Transition Time Filter Impact on COM and RITT (Comment i-49 and i-50)

IEEE 802.3 25 Gb/s Ethernet Task Force, January 2016, Atlanta GA

COM vs Measured Transition Time

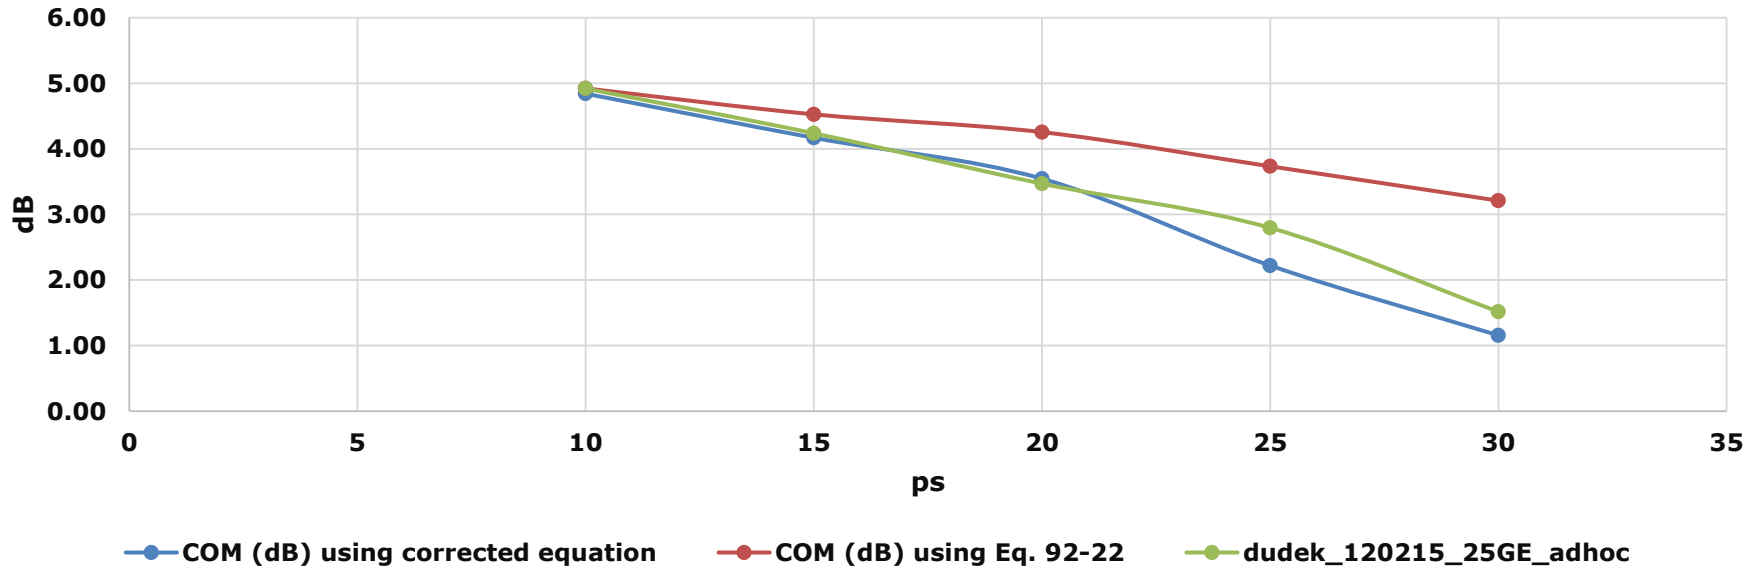
Impact on COM for test channel is large for slow transition times

COM computed with SNR_{Tx}=100 (no added noise) and "ideal termination"

No Causality Correction performed

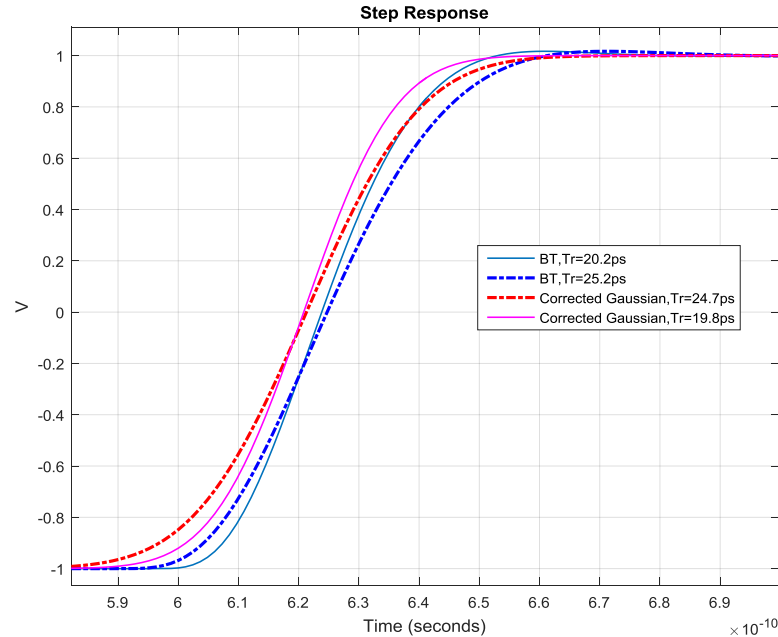
Tr 20ps and 25ps BT and Corrected Gaussian responses look similar

Added BBN vs Transition Time

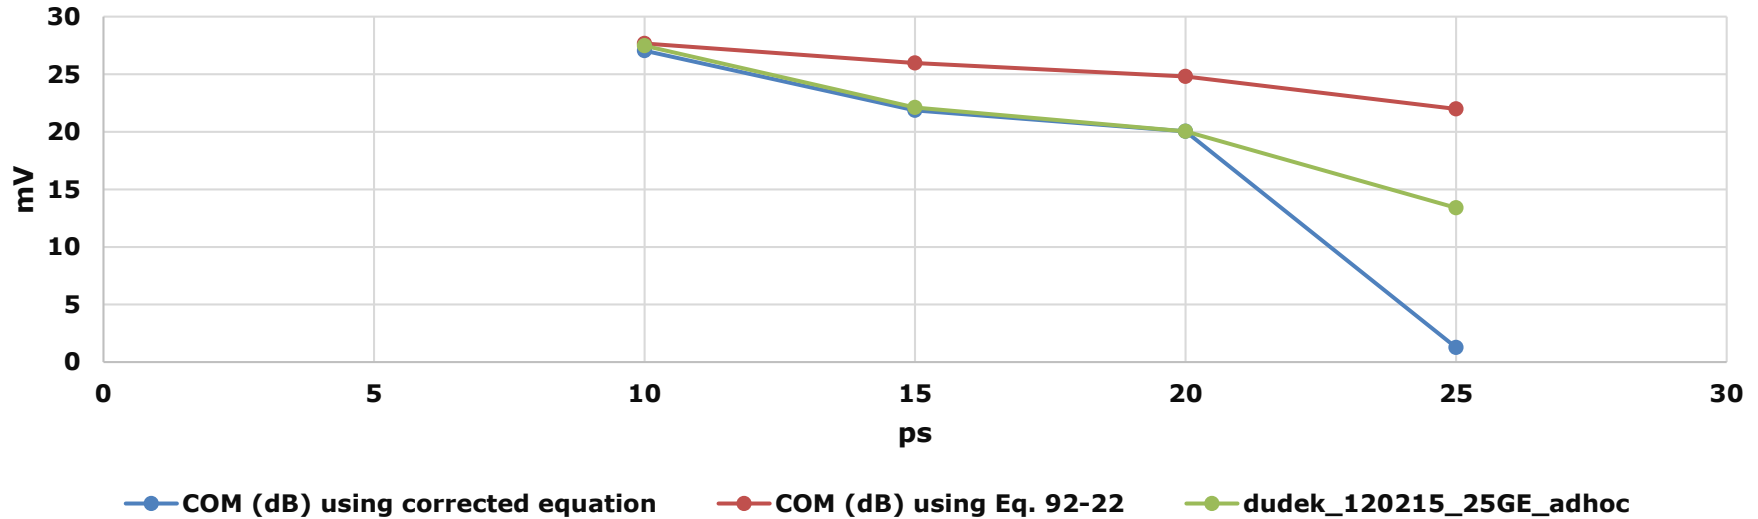
Original equation requires much more BBN noise for RITT

Corrected Gaussian and dudek_120215_25GE_adhoc have same BBN for transition times 20 ps and lower

No Causality Correction performed

- **Use corrected causal Gaussian filter cable RITT**
- **T_r_filter_type = 1 in COM version 162a**
 - T_r_filter_type = 0 or unspecified is backwards compatible
